CROW BUTTE RESOURCES, INC.
(In Situ Leach Facility, Crawford, NE)Docket No. 40-8943
License SUA-1543

**CONSOLIDATED REQUEST FOR HEARING
AND PETITION FOR LEAVE TO INTERVENE**Office of the Secretary
U.S. Nuclear Regulatory Commission
Washington, DC 20555-0001

Figure 1. Chart of aquifer exempt zone (i.e., zone surrounded by monitoring wells) and locations for baseline wells established with valid statistical methods.

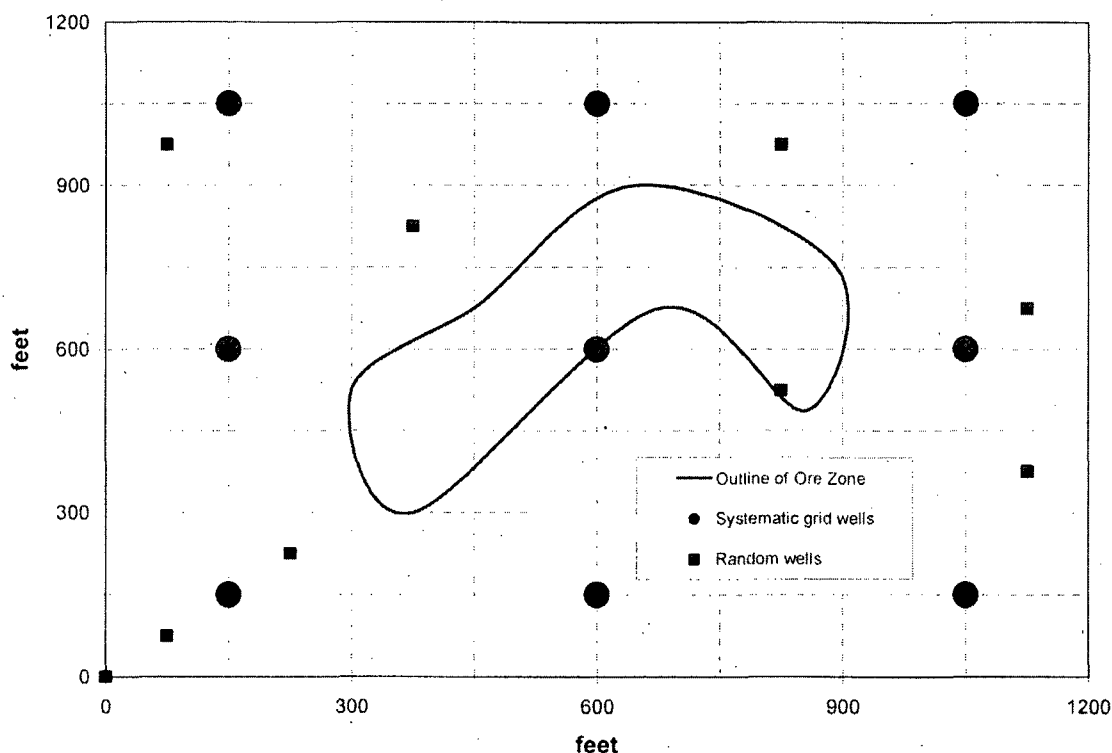
Figure 2.9-2 illustrates the proposed aquifer exemption zone around the ore bodies, and there is no statistical justification for the location of the baseline wells to validate that the results in Table 2.9-4 represent the water quality in the exempt zone. Note that the baseline wells in Figure 2.9-2 are clustered and not spread out over the entire exempt zone, and this violates statistical protocol. Within the aquifer exemption zone (i.e., the zone within the monitoring well ring), a systematic grid must be laid out to determine the location of the baseline water-quality wells. The density of nodes within the grid will be determined by the size of the area and the data quality objectives. Data quality objectives (EPA 2000a & 2000b) state the statistical confidence one wishes to have in the estimate of the mean (normal or log normal distribution) or median (no defined distribution) for the water-quality parameters. If a high level of confidence is required for an estimate of the mean or median, more baseline wells will be required.

- 9) No justification is provided for the location of water-quality wells within the monitoring ring on Figure 2.9-2. Valid statistical methods must be used to locate the systematic or random samples on a grid than covers the entire area enclosed by the monitoring wells.

Alternatively, we may elect to locate wells on the grid using a random number generator. In general, less wells are required if they are located randomly, and this is shown on Figure 1 as two random locations per quadrant. Free modeling software, developed by the Pacific Northwest National Laboratory for the Department of Energy (PNNL 2007), allows a large number of scenarios to be evaluated to determine the optimum data quality objectives and sampling approach for the stakeholders.

Figure 2. Cross section of an aquifer (20 to 90 feet) showing improper (Well 1) and proper (Well 2) sampling intervals to obtain a representative sample.

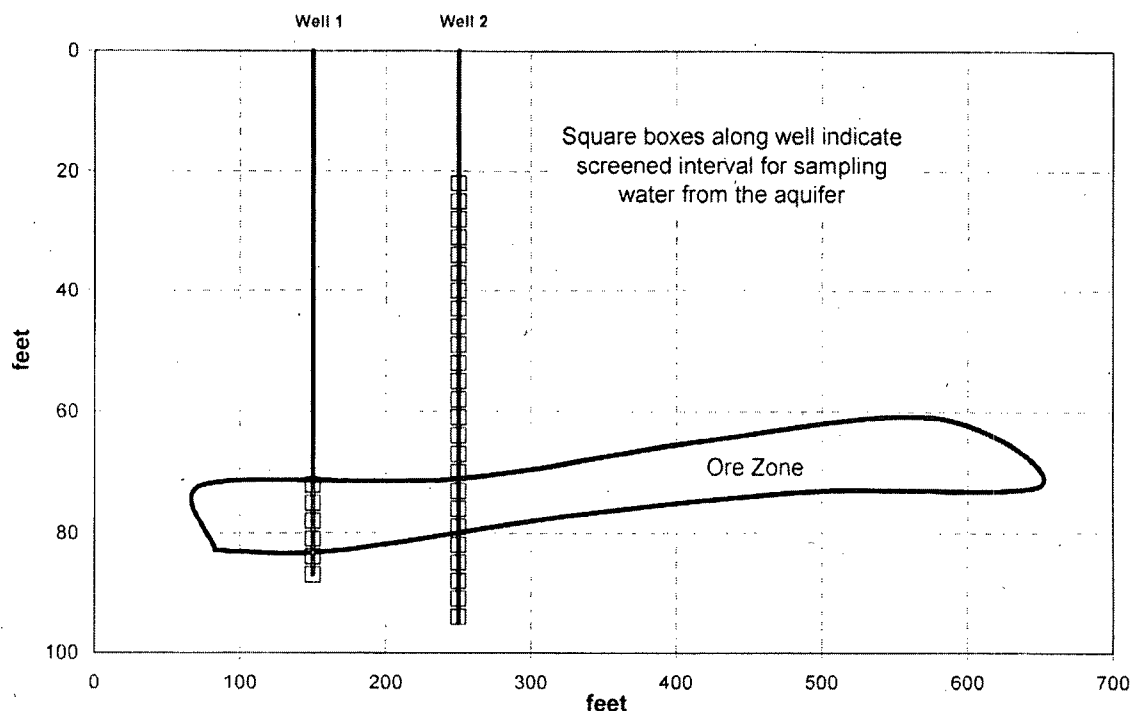
The well logs provided indicate the Chadron is approximately 50 to 80 feet thick through most of the mining area (Figures 2.6-4 through 2.6-11). The sampling interval for the baseline wells is 20 feet (Table 2.9-3), which does not represent the entire thickness of the aquifer. Figure 2 shows that a water sample obtained from Well 1, screened only in the ore zone, returns a biased sample that does not represent the water quality of the column of water at the given location. Well 2 (Figure 2) indicates the correct method for sampling the water, which requires that the entire thickness of the aquifer be screened to obtain a representative sample.

- 6) Figures 2.6-4 through 2.6-11 show the thickness of the Chadron to be 40 to 80-feet thick through most of the mine area. Therefore, it is inappropriate to use a screened interval of 20 feet to sample the groundwater from the ore zone (Table 2.9-3). The entire thickness of the aquifer must be sampled to obtain a representative sample.

Figure 3. Probability plot indicating that all data do not lie near or on a straight line, which rules out a normal or log normal distribution.

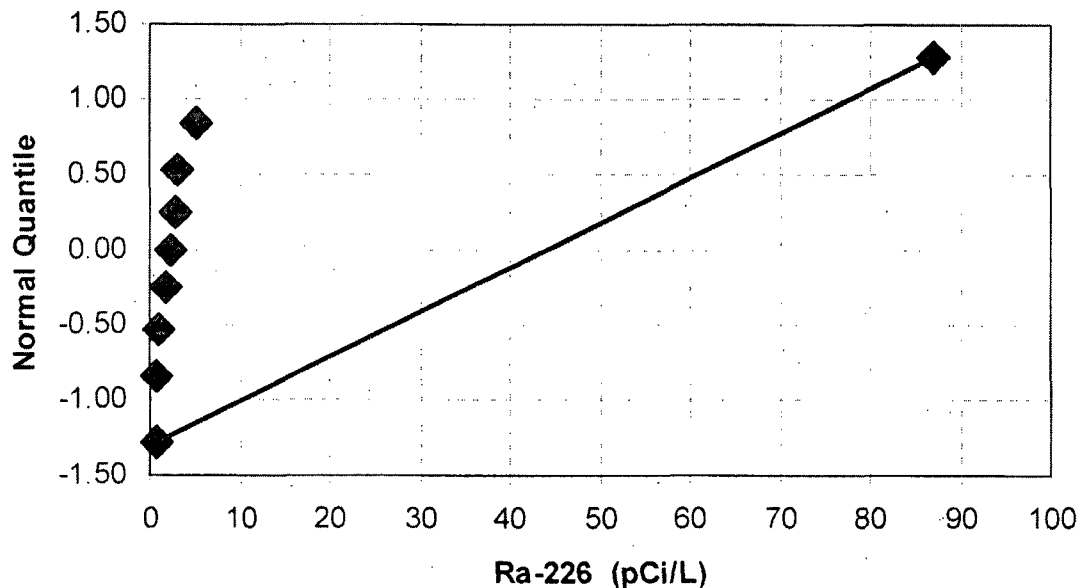
A probability plot of the data (Figure 3) and the results of the Shapiro-Wilk test confirm this. The normal-quantile values must fall on a straight line or the Shapiro-Wilk probability values must exceed 0.05 (at the 95 percent confidence level) for a normal or log normal distribution to be declared, which is clearly not the case. Therefore, the median, and not the mean, must be used to represent the central tendency of the data. Note that inappropriate use of the mean results in a high bias on the estimate of the baseline value for radium-226, which improperly elevates restoration clean-up levels and lowers the costs associated with the number of pore volumes needed to exchange to meet the clean-up levels.

Figure 4. Proper use of a control chart to determine lixiviant excursions.

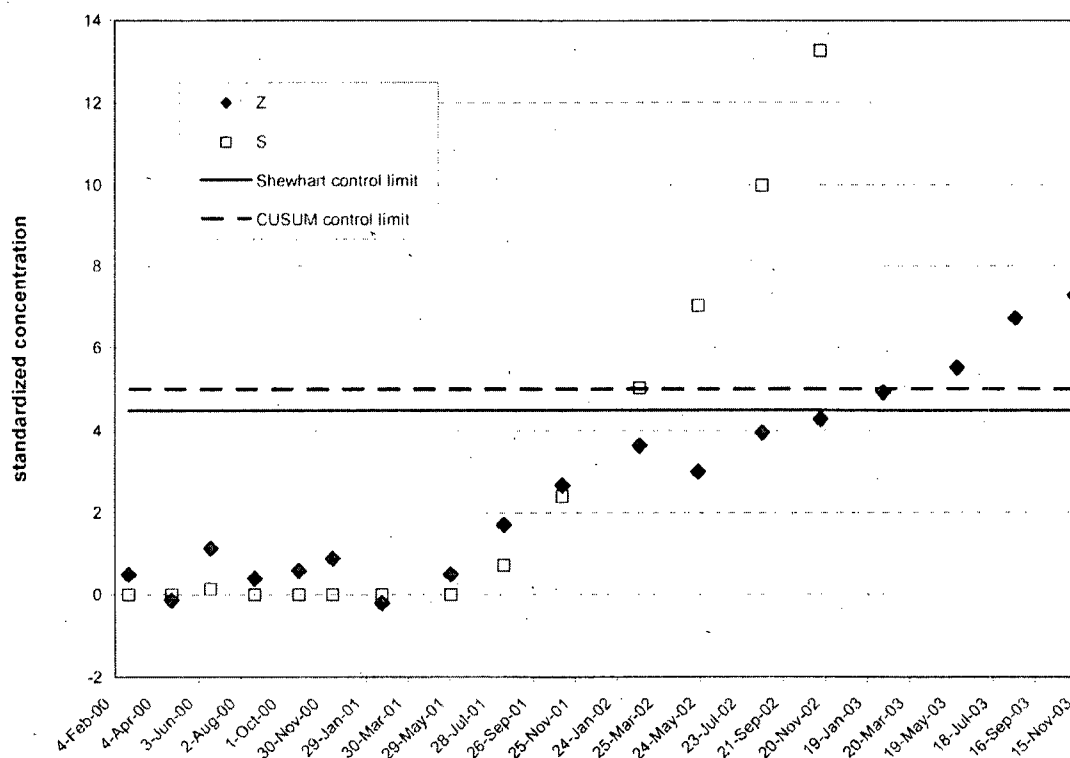
Figure 4 illustrates the importance of using the SCL and CUSUM for monitoring lixiviant excursion. The SCL (Z) and CUSUM (C) are plotted for an excursion parameter, a gradual increase in contamination exceeds the CUSUM limit in February of 2002, while the SCL limit is not exceeded until January of 2003. The SCL limit is similar to the CBR's use of 5 standard deviations above the mean for any one sampling event, although EPA recommends 4.5 standard deviations for any one sampling event. Using only the SCL limit allows contamination to migrate beyond the monitoring well for nearly a year before an excursion is declared. Therefore, if the CUSUM is not used with the SCL limit a gradual increase in contamination will not be detected and migration of diluted lixiviant will pass the monitoring well without corrective action.
